Upfleet, Vale of Health, NW3 1AN ref. 2020/4024/P

Delegated Report (Members Briefing)			Expiry Date:	30/10/2020
		N/A	Consultation Expiry Date:	25/10/2020
Officer			Application Number(s)	
Josh Lawlor			2020/4024/P	
Application Address			Drawing Numbers	
Upfleet Vale Of Health London NW3 1AN			See decision notice weird	
PO 3/4	Area Team Signature	C&UD	Authorised Officer Signature	
Proposal(s)				
Raising height of existing rear extension. Formation of window from Juliet balcony at first floor				
Recommendation(s):	Grant Conditional Planning Permission			
Application Type:	Full Planning Permission

Proposal: Raising height of existing rear extension. Removal of balcony and formation of window with single pane from french doors at first floor

6. Compliance with 45 degree test in elevation

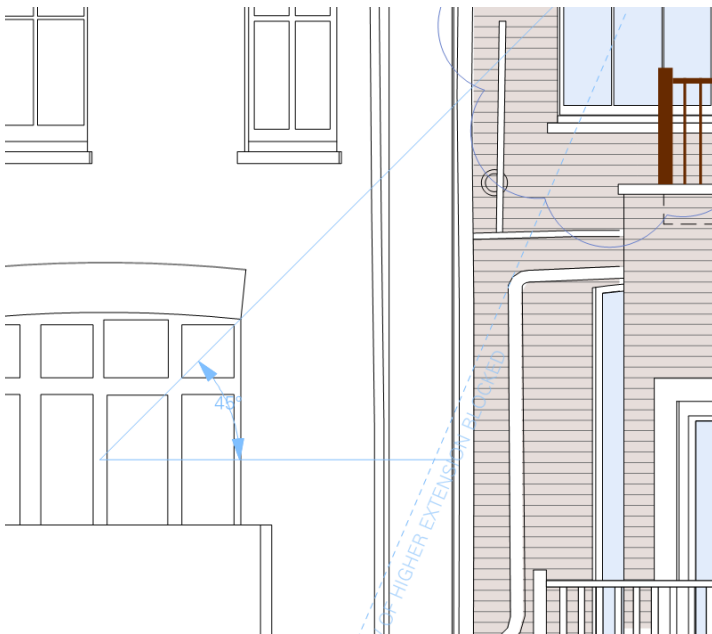
- 5.3. The extension would comply with the 45 degree test (basic sunlight/daylight test) on elevation, measured against the nearest neighbouring windows at lower ground and first floor. It is noted that the depth of the extension from the original rear elevation would not increase. The extension would therefore have little to no discernible impact on light to neighbouring properties at Silverdale or 12 Heath Villas. In accordance with CPG Amenity 2018, as the proposal complies with the 45 degree test there is no requirement for the submission of fully surveyed daylight and sunlight assessment. In addition, the extension would not reduce outlook nor lead to a sense of enclosure to neighbouring rear windows. The height of the extension would be raised by 920mm which would not block any views from neighbouring windows. There would not be a material increase to light spillage over the existing situation.
